ECN/PCN No.:

For Manufacturer			
<b>Product Description:</b> 10/100Base-Tx RJ45, Tab UP	<b>Abracon Part Number / Part Series:</b> ARJC01-111002L	<input type="checkbox"/> Documentation only <input checked="" type="checkbox"/> ECN <input type="checkbox"/> EOL	<input type="checkbox"/> Series <input checked="" type="checkbox"/> Part Number(s)
<b>Affected Revision:</b> B	<b>New Revision:</b> C	<b>Application:</b>	<input type="checkbox"/> Safety <input checked="" type="checkbox"/> Non-Safety

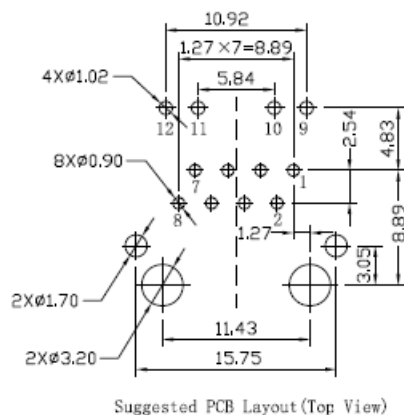
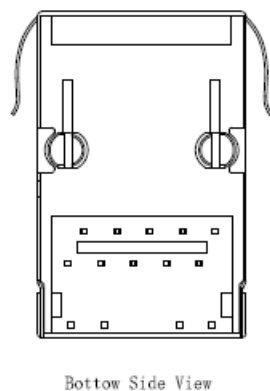
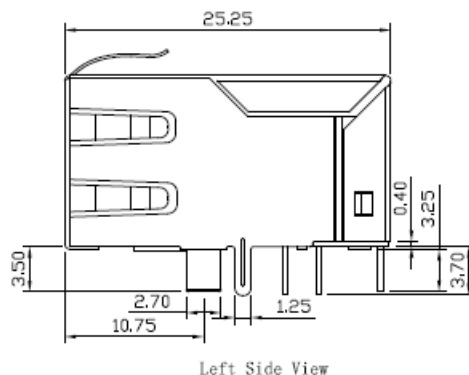
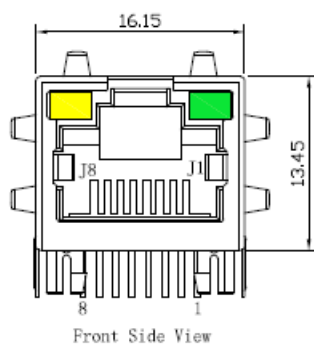
**Prior to Change:**  
 Dimensions: 16.20 x 13.65 x 25.40 mm

**After Change:**
**Dimensions: 16.15 x 13.45 x 25.25 mm**

Moving to new production line. Updating graphics/drawings due to slight changes in dimensions.

Mechanical dimensions are so minimal they will not impact products form, fit or function.
